STATE OF CALIFORNIA  
ENERGY RESOURCES CONSERVATION  
AND DEVELOPMENT COMMISSION

In the Matter of:	)	Docket No. 01-AFC-12
	)	
Application for Certification of the	)	<b>STAFF'S SUPPLEMENTAL</b>
Los Esteros Critical Energy Facility	)	<b>TESTIMONY</b>
_____	)

### 24-HOUR CONSTRUCTION SCHEDULE IMPACTS

**SUPPLEMENTAL AIR QUALITY Figure 1**  
**Monthly Maximum & Minimum Ambient 24-hour Average PM10 Levels**  
**4th Street & Tully Road (San Jose)**  
**January 1995 – June 2001**

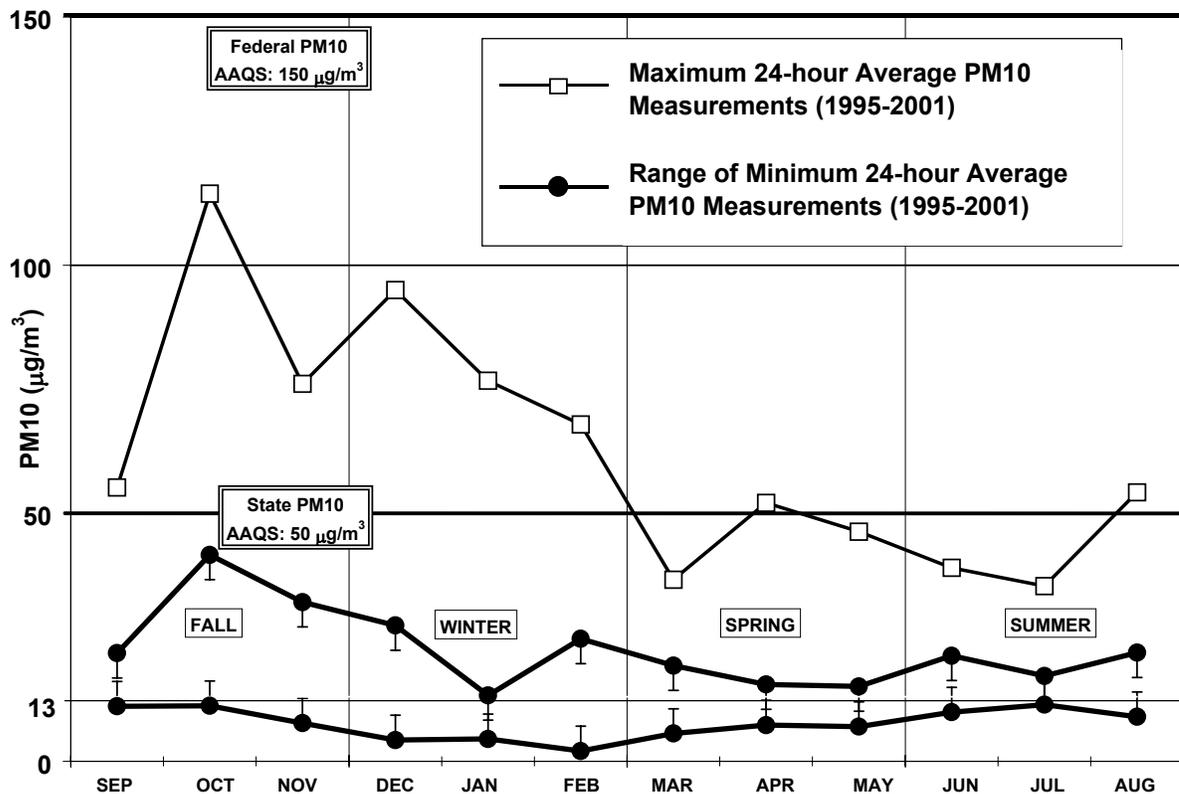
**SUPPLEMENTAL AIR QUALITY Figure 1** below presents the combined monthly maximum & range of minimum ambient PM10 levels for January 1995 through June 2001 from the 4<sup>th</sup> Street monitoring station in San Jose (about 7 miles south south-east of the project site) and the Tully Road monitoring station (about 13 miles south south-east of the project site).

Given the predicted worst case 24-hour average PM10 construction impact of  $37 \mu\text{g}/\text{m}^3$  presented in the applicant's modeling analysis, any time the ambient PM10 concentration is at or above  $13 \mu\text{g}/\text{m}^3$  the construction could cause or contribute to a violation of the state 24-hour average AAQS. As can be seen from **SUPPLEMENTAL AIR QUALITY Figure 1**, the local ambient 24-hour average PM10 level is frequently above  $13 \mu\text{g}/\text{m}^3$ . This would be especially true if construction occurs during the fall and/or winter quarters when ambient PM10 levels are routinely at their highest.
